# FINAL DRAFT MINUTES

## May 18, 2023 Standards Committee Meeting

RE: Minutes from the May 18, 2023 Standards Committee Meeting

SECTION 801 – TRAFFIC CONTROLS FOR CONSTRUCTION AND MAINTENANCE OPERATIONS

PROPOSED FIGURE TO BE SHOWN IN GENERAL INSTRUCTIONS TO FIELD EMPLOYEES (GIFE)

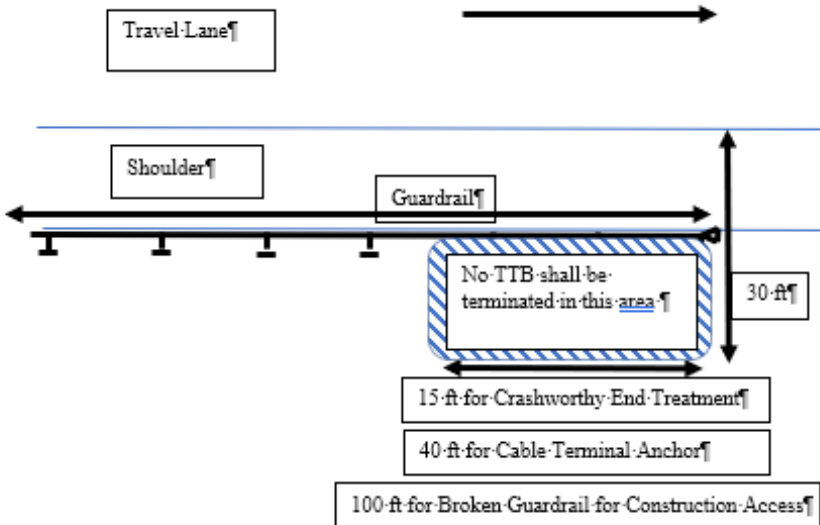
Where temporary traffic barrier is terminated behind guardrail within 30 ft from the edge of the adjacent travel lane, the ends of the TTB shall not be within 10 feet of the face of guardrail, and the TTB shall overlap:

- → a crashworthy guardrail end treatment by more than 15 ft,
- → a guardrail cable terminal anchor by more than 40 ft, or
- → a run of guardrail that has been broken for construction access by more than 100 ft.

No portion of the temporary traffic barrier shall be within 10 ft behind the face of guardrail.
